ADDENDUM NO. 03
TO THE
CONTRACT DOCUMENTS

FOR
TAXIWAY A REHABILITATION (WEST)

AT
SYRACUSE HANCOCK INTERNATIONAL AIRPORT
SYRACUSE, NEW YORK

AUGUST 11, 2023

- LIGHT DETAIL NOTES:**
- REFER TO SHEET EP-01 - EP-04 FOR LIGHT FIXTURE LAYOUT LOCATION.
 - LIGHT BASES SHALL BE INSTALLED WITH CARE TO ASSURE VERTICAL & AZIMUTH ALIGNMENT OF FIXTURE.

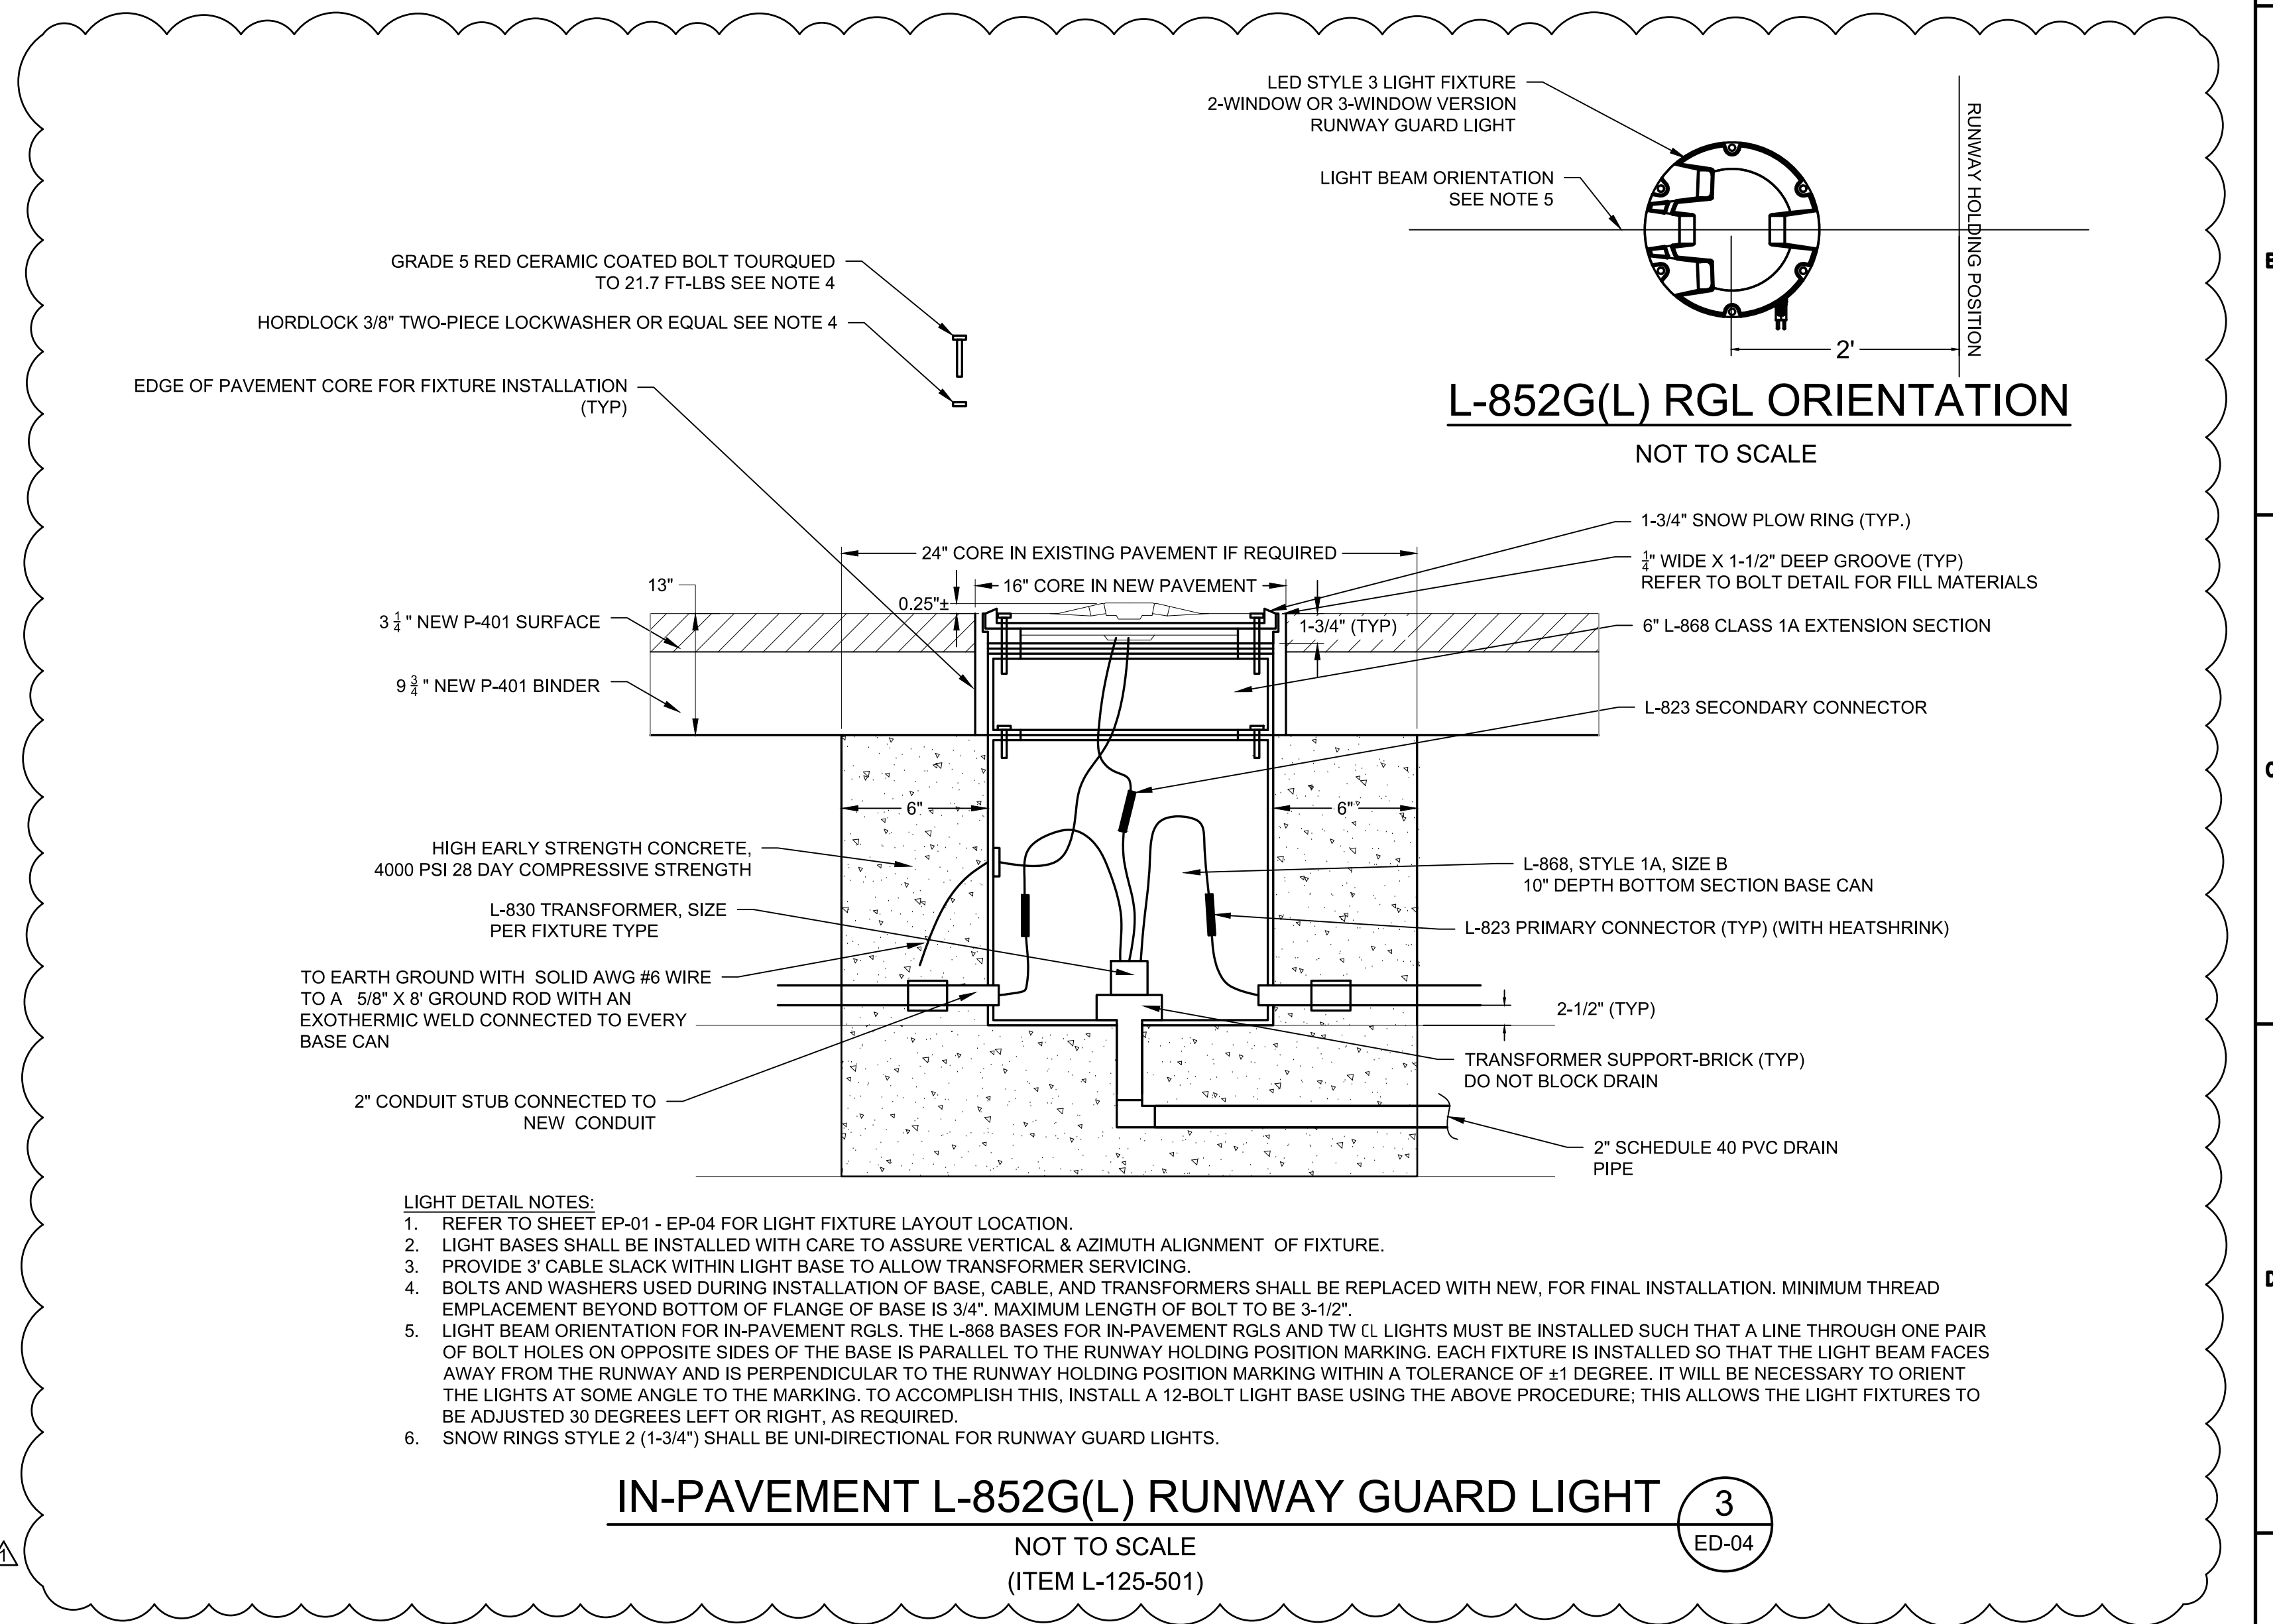
Clarification: Details and notes have been revised to reflect correct equipment specifications and address erroneous discrepancies. Additional details pertaining to Runway Guard Lights have been added. Detail sheet numbers have been revised on individual detail labels to correct erroneous entries.

REV	DATE	DESCRIPTION	BY
	8/11/2023	ADDED DETAIL SHEET NUMBERS - ADDENDUM 3	SGJ
	8/11/2023	ADDED RGL DETAIL - ADDENDUM 3	SGJ

MARKING PLAN (SHEET 3 OF 4)

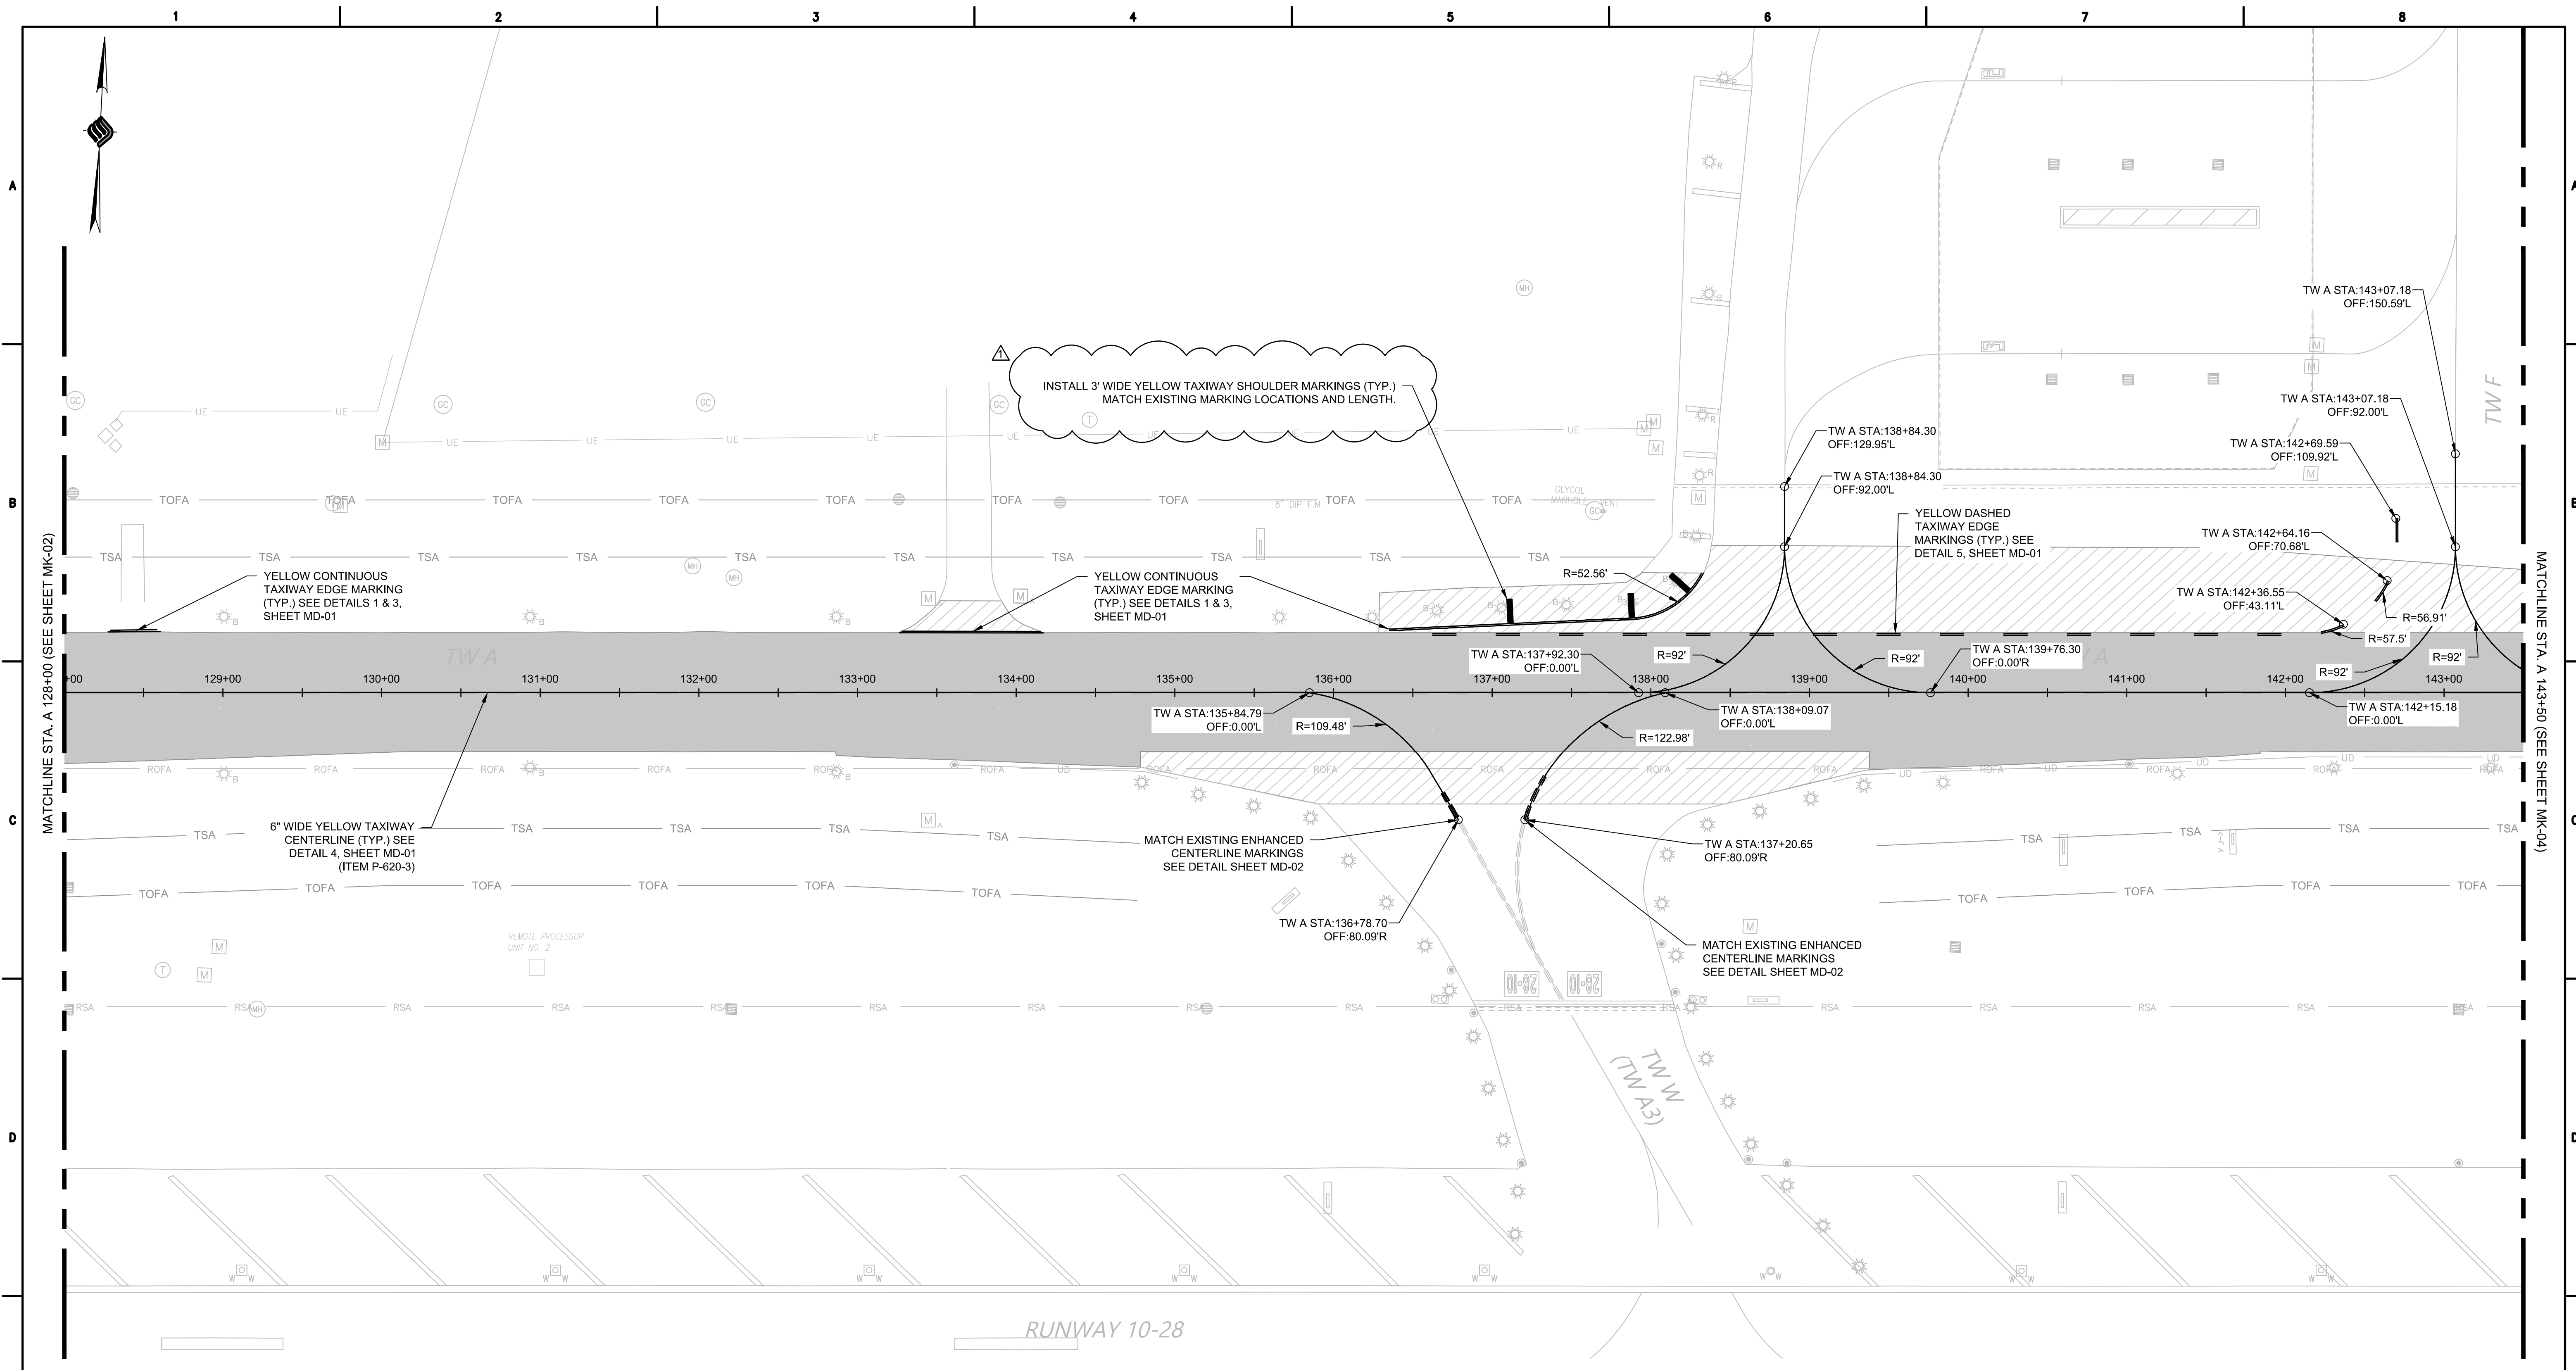
Clarification: A callout has been added to identify and describe proposed shoulder markings.

REV	DATE	DESCRIPTION	BY
	8/11/2023	ADDED SHOULDER MARKING CALLOUT - ADDENDUM 3	SGJ
